SUBJECT: AMENDMENT NO. 44 TO FACILITY OPERATING LICENSE NO. NPF-43:
(TAC NO. 75279)

FERMI-2

ATTACHMENT TO LICENSE AMENDMENT NO. 44

SAFETY EVALUATION BY THE OFFICE OF NUCLEAR REACTOR REGULATION
RELATED TO AMENDMENT NO. 44 TO FACILITY OPERATING LICENSE NO. NPF-43

FIGURE 3.2.1-3

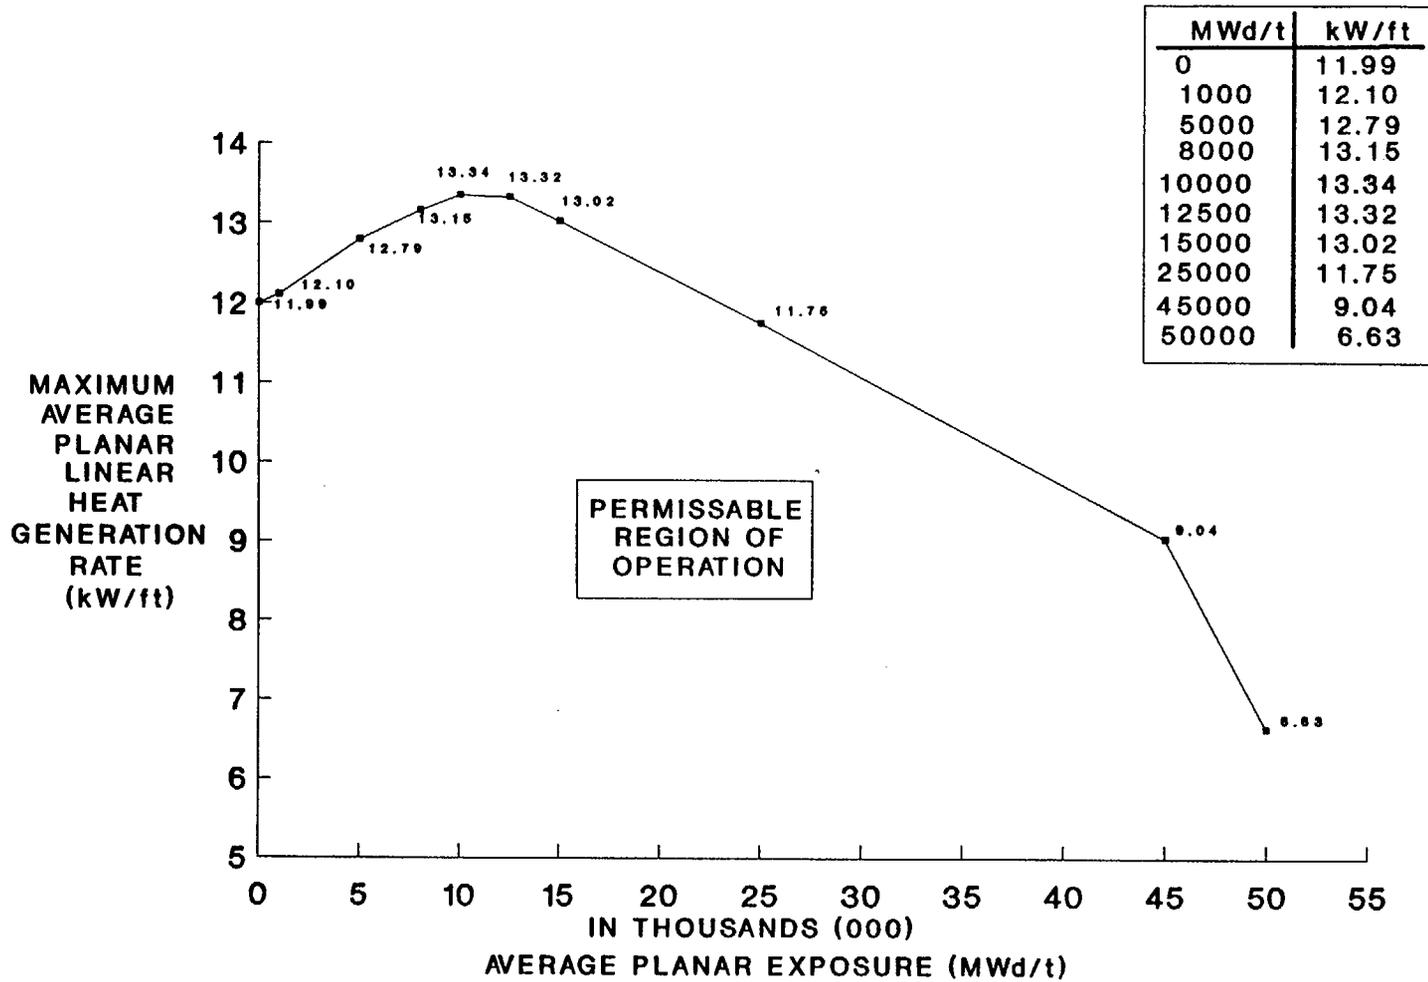
In both figures, one point specified for the joining of two line segments was not graphically plotted consistent with the tabular information. In both figures, the point tabularly indicated to be associated with 12,500 MWD/t was graphically plotted at 12,000 MWD/t. Further, the heading for the MWD/t column in both figures is incorrectly given as "MWD/" rather than the correct units of "MWD/t."

The November 16, 1989 submittal contained revised Figures 3.2.1-3 and 3.2.1-4 with the graphs replotted to correctly indicate the RLS information. A corrected heading for the Average Planar Exposure column of the table is also included.

4.2.3.1 MCPR, with:

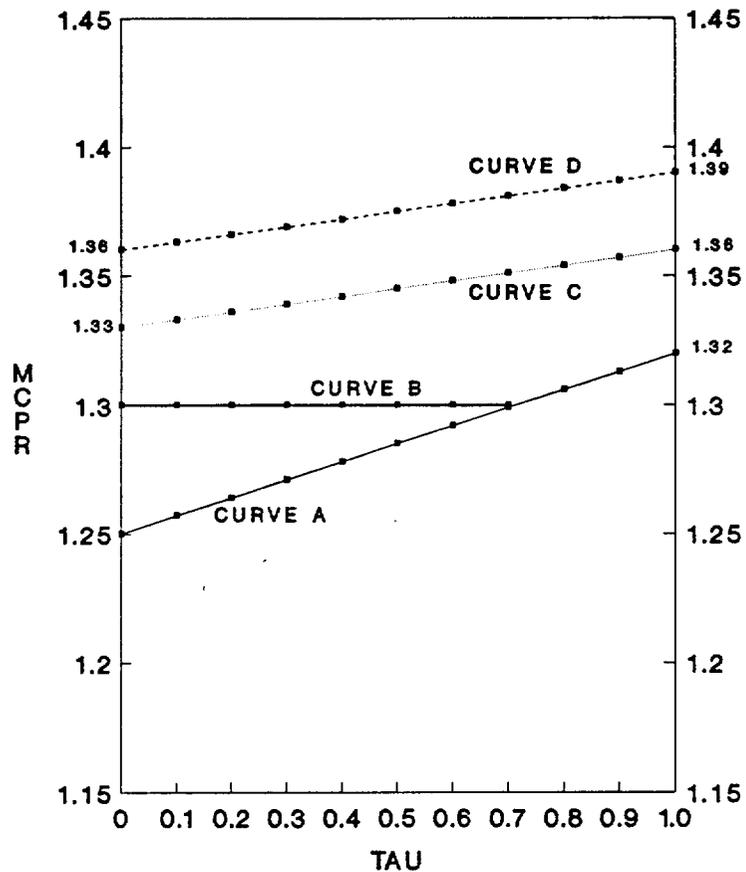
In addition, typographical errors were found in the designation of fuel bundle types in Specification 3.2.4 and a reference to figures in Specification 4.2.3.1 was not changed to match the addition of new figures. The purpose of the November 16, 1989, application is to correct these errors.

Amendment No. 42 revised Specification 3.2.4 to indicate separate Linear Heat Generation Rate (LHGR) limits for different fuel bundle types. In Amendment No. 42, bundle types 8CR183 and 8CR233 were incorrectly identified as BCR183 and BCR233. Also, in Specification 4.2.3.1 reference to Figure 3.2.3-1 was not changed to include new Figures 3.2.3-1A and 3.2.3-1B. The new figures were created by the specification of MCPR limits based upon core exposure. Specification 4.2.3.1 is proposed to be changed in a manner similar to that approved in Amendment No. 42 for Specification 4.2.3.2 to ensure that all of the curves are referenced.

shall be determined to be equal to or greater than the applicable MCPR limit determined from Figures 3.2.3-1 through 3.2.3-1B and 3.2.3-2:

FIGURE 3.2.3-1

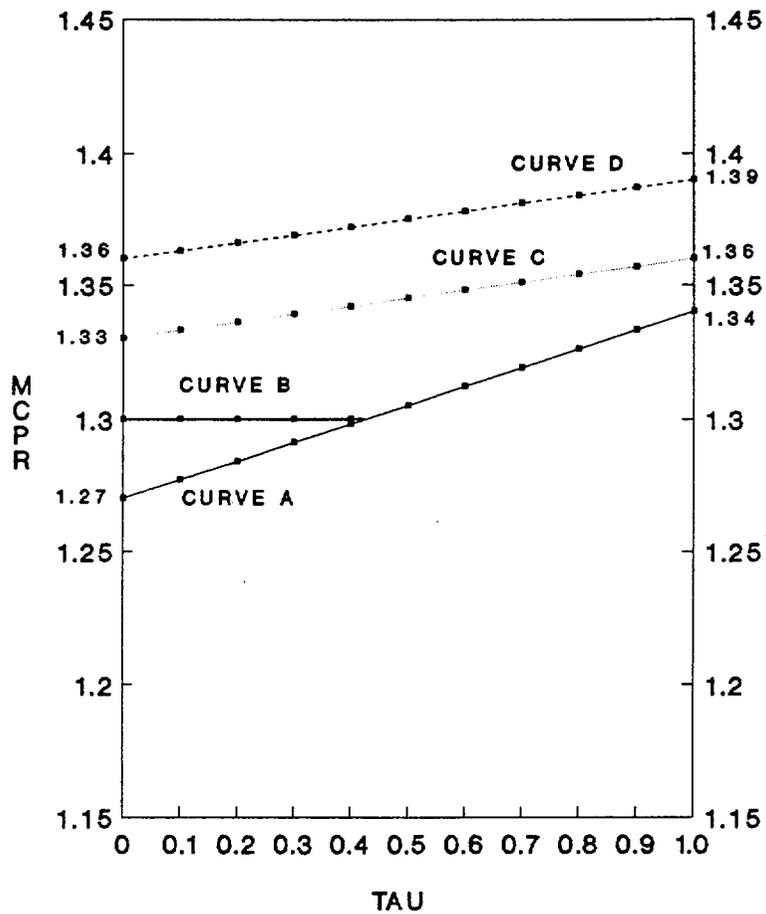
The nomenclature associated with Curve C and Curve D, which appears on each of these figures, was found to be unclear as proposed in the April 3, 1989, application and as issued in Amendment No. 42. The nomenclature is proposed to more clearly indicate which equipment is assumed to be out-of-service for the two curves. Previously, the terminology "without a piece of equipment" was used to mean "with the equipment out-of-service." The proposal is strictly editorial and makes no change to the intent or application of the curves.

On Figure 3.2.3-1, the MCPR value for tau equal to 1.0 for the merged Curve A and B is not given on the figure. This point corresponds to a MCPR of 1.32. This value is the "Option A" most limiting pressurization event for the exposure range "BOC2 to EOC2 - 2000 MWD/St" located on RLS page 13.

On all three figures, Curve B is a hybrid of two limiting events. One is the non-pressurization event of a rod withdrawal error which has a limiting MCPR of 1.30 for GE8x8EB fuel (see RLS page 13). The other is the pressurization event for the core exposure of concern which yielded Curve A. Thus, Curve B is a constant 1.30 for tau less than the tau for the point where the Curve A event becomes more limiting.

FIGURE 3.2.3-1A

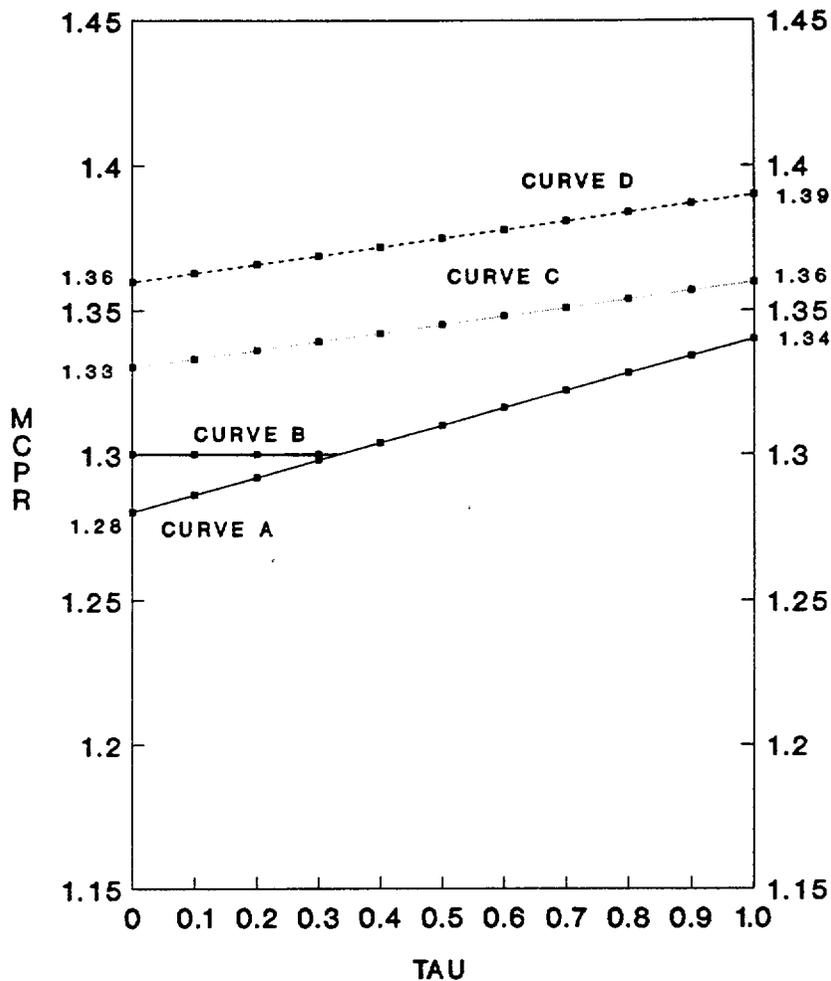
On Figures 3.2.3-1A and 3.2.3-1B a value of less than 1.30 appears to be indicated for a portion of Curve B which should be a constant 1.30. This occurs near the point where Curves A and B join. This proposal corrects Curve B for these two figures by indicating the correct value of 1.30 for the constant MCPR segments of Curve B.

FIGURE 3.2.3-2

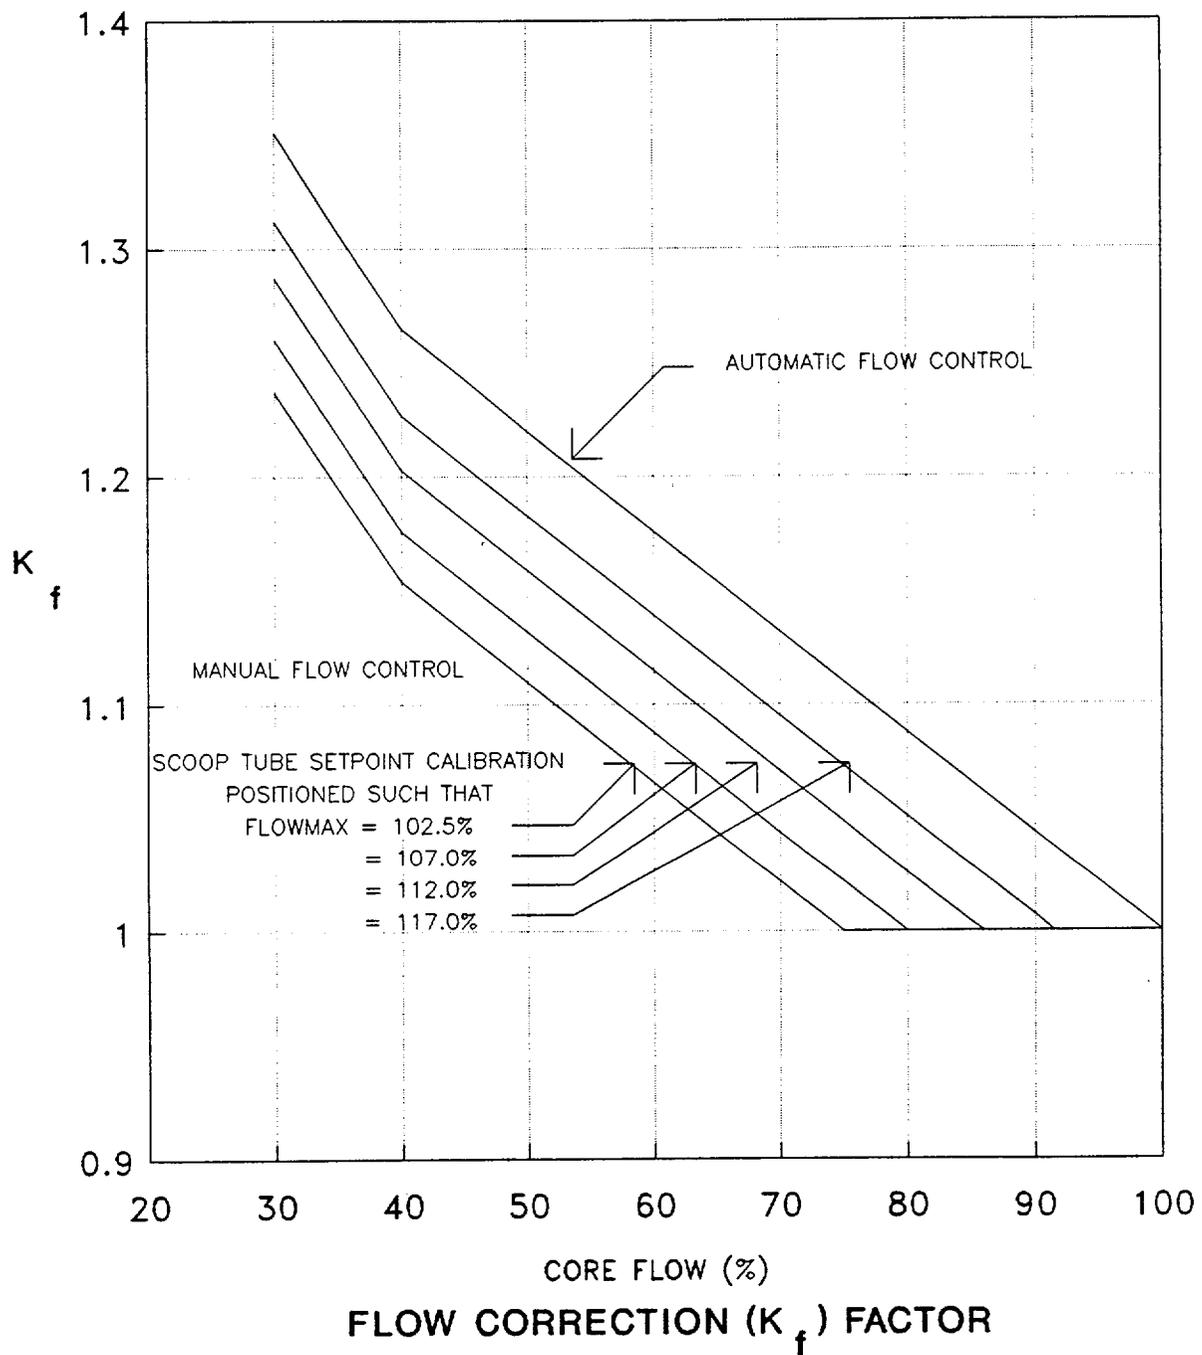
The amendment revises the TS Figure 3.2.3-2, Flow Correction (K_f) Factor. The figure was part of a previous license amendment request dated April 3, 1989, and issued by the NRC as Amendment No. 42 to the Fermi-2 Operating License and was recently found to be in error. Further review of other figures issued in Amendment 42 determined that five other figures submitted should be modified to more clearly show the limits they impose upon plant operation. In addition, some administrative or typographical errors were found in the designation of the fuel bundle types in Specification 3.2.4 and in the referencing of new figures in Specification 4.2.3.1. Minor corrections to the Bases were also found to be necessary.

Flow Correction (K_f) Factor as a function of Core Flow (%) is provided in Figure 3.2.3-2. The Operating Limit MCPR determined from the use of Figure 3.2.3-1, 3.2.3-1A, or 3.2.3-1B (depending on core exposure) is multiplied by K_f . This increases the MCPR limit further to account for a potential Reactor Recirculation Pump Runout transient. Since the severity of this transient depends on the Flow Control Mode and, if in manual mode, the Scoop Tube Set Point Calibration, five curves are provided to account for the possible configuration.

As discussed above under Introduction, these figures were incorrectly drawn in the preparation of the April 3, 1989, application. The sole change to these figures is to provide the correct curves.

The new K_f values were made necessary for Cycle 2 due to the application of the GEXL-PLUS critical power correlation to the Cycle 2 reload licensing analyses. The Cycle 1 analysis used the GEXL correlations. Both correlations provide a means to relate bundle critical power, that power which leads to transient boiling, to parameters which can be sensed and provided to the plant process computer.

The sole purpose of the proposed change is to correct an administrative error made in the preparation of the April 3, 1989, application. No change to the underlying accident analysis has been made.
